NAVAJO TRANSMISSION PROJECT

FINAL ENVIRONMENTAL IMPACT STATEMENT AUGUST 1997

Title: Navajo Transmission Project Final Environmental Impact Statement (FEIS)

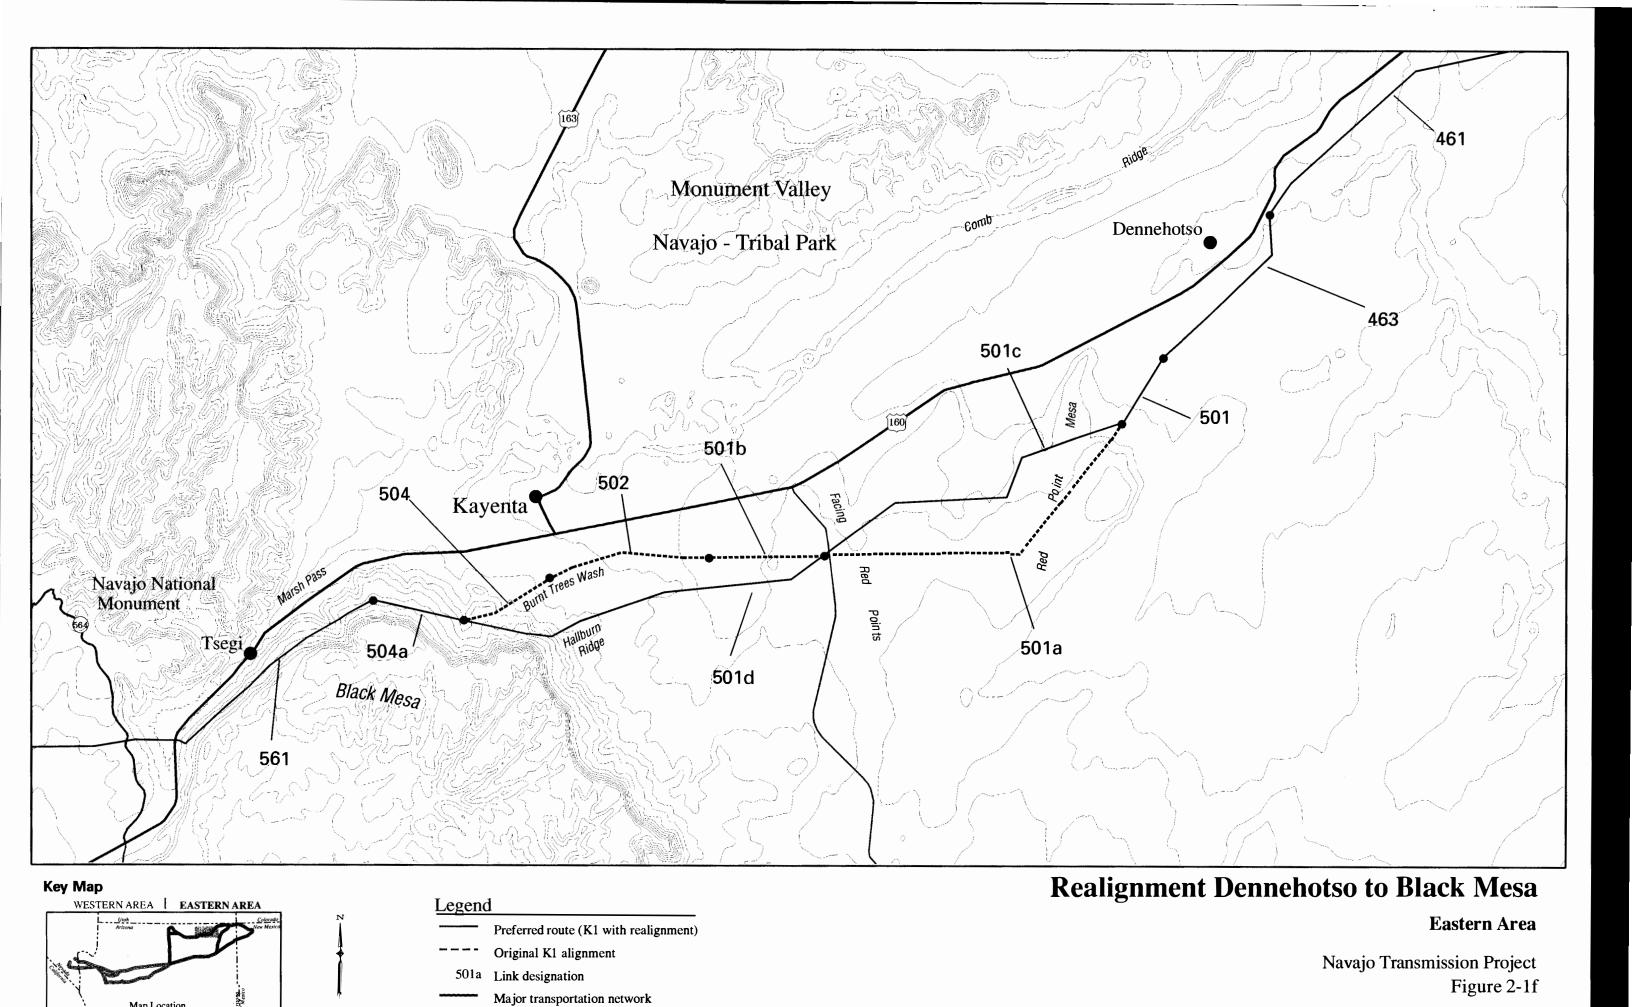
The realignment would replace portions of Links 501, 502, and 504 along K1. For purposes of characterizing and comparing the alternative segments, new link designations were given to the links of the original K1 alignment and new K1 alignment in this area. As shown on Figure 2-1f, the original segment was divided into Links 501a, 501b, 502, and 504. The realignment is designated by Links 501c and 501d.

The realignment varies from the original route in this area as it continues west near the junction of links 463 and 501 up to and across Red Point Mesa. As opposed to the original route (link 501a), the realignment (Link 501c) is located approximately 1.5 to 2.0 miles north and west of Link 501a before crossing back to the south of Link 501b and continuing west between Facing Red Points. As this alternative continues west toward Black Mesa, it is located approximately 1.0 to 2.0 miles south of Links 501b, 502, and 504. The original alignment was located north of the Burnt Trees Wash and closer to the town of Kayenta, whereas the realignment crosses Hallburn Ridge to the south as it climbs up to the northern edge of Black Mesa and joins with Link 504a on the K1 route.
